METROPOLITAN GOVERNMENT OF NASHVILLE AND DAVIDSON COUNTY

**STAFF RECOMMENDATION**  
**1610 Gartland Avenue**  
**June 17, 2020**

Metropolitan Historic Zoning Commission  
Sunnyside in Sevier Park  
3000 Granny White Pike  
Nashville, Tennessee 37204  
Telephone: (615) 862-7970  
Fax: (615) 862-7974

**Application:** New Construction—Addition  
**District:** Lockeland Springs-East End Neighborhood Conservation Zoning Overlay  
**Council District:** 06  
**Base Zoning:** R6  
**Map and Parcel Number:** 08310015500  
**Applicant:** Craig Kennedy, Bootstrap Architecture + Design  
**Project Lead:** Sean Alexander, sean.alexander@nashville.gov

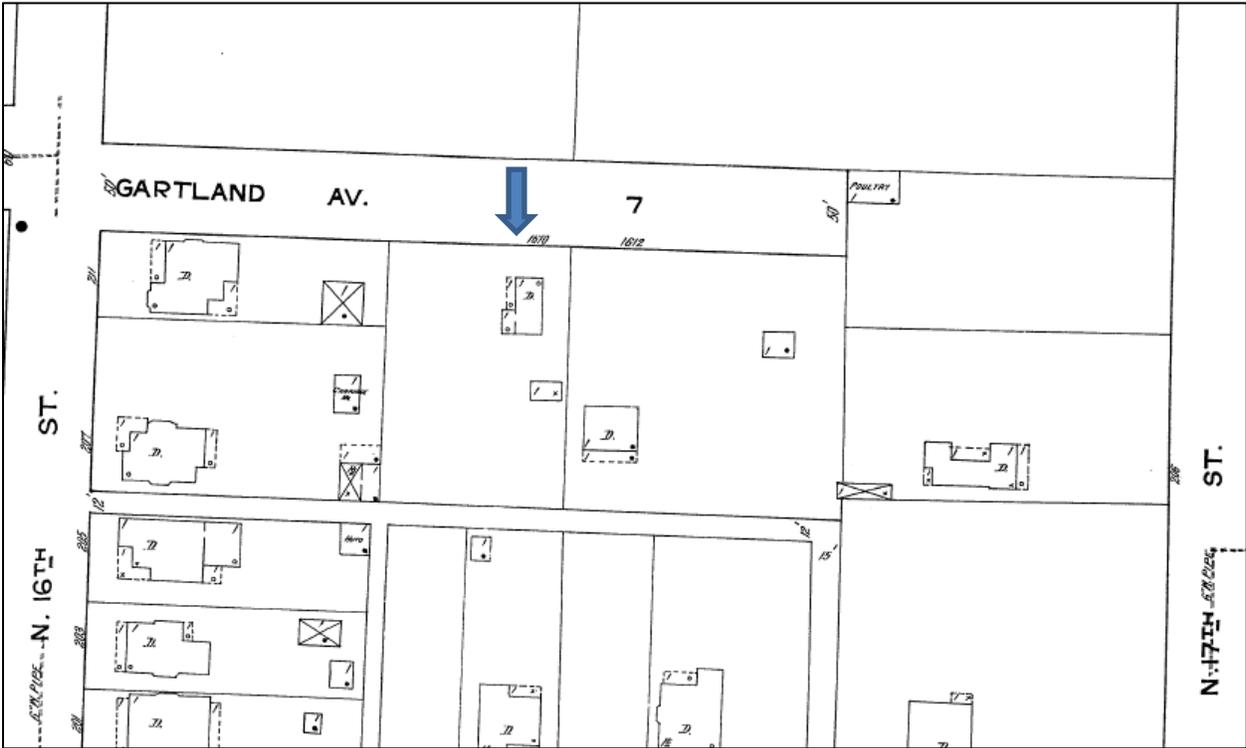
The left-side dormer is not primarily glazing as is typical of dormers historically, but because this section of the addition is stepped in eleven feet (11') from the side and will be largely obscured by the existing side-gabled roof, staff finds that it may be appropriate.

1610 Gartland Avenue, left side. Non-original shed-roofed addition to at the rear (to the left in photo) will be demolished.

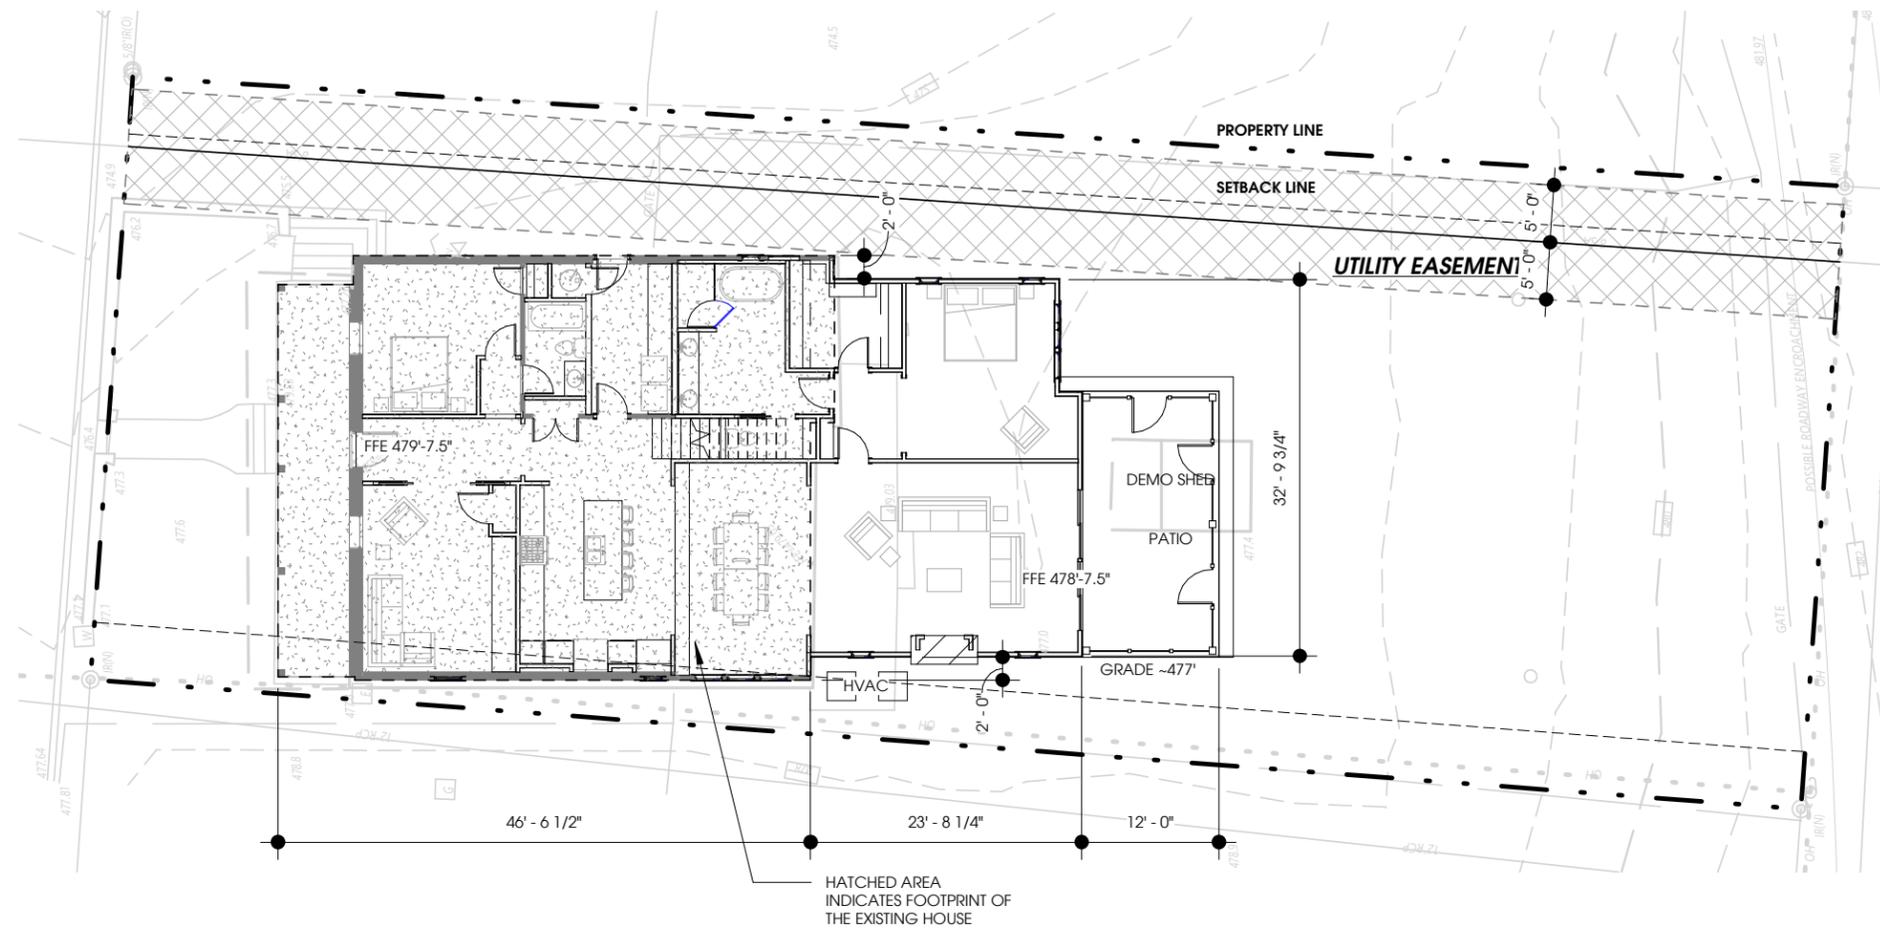
**Demolition:** The project involves demolishing a portion of the rear-facing wall of the house and an earlier rear addition. Because this section is an addition, it is not significant to the historic character of the house its demolition is appropriate.

Staff finds that this partial demolition meets section III.B.2 of the design guidelines.
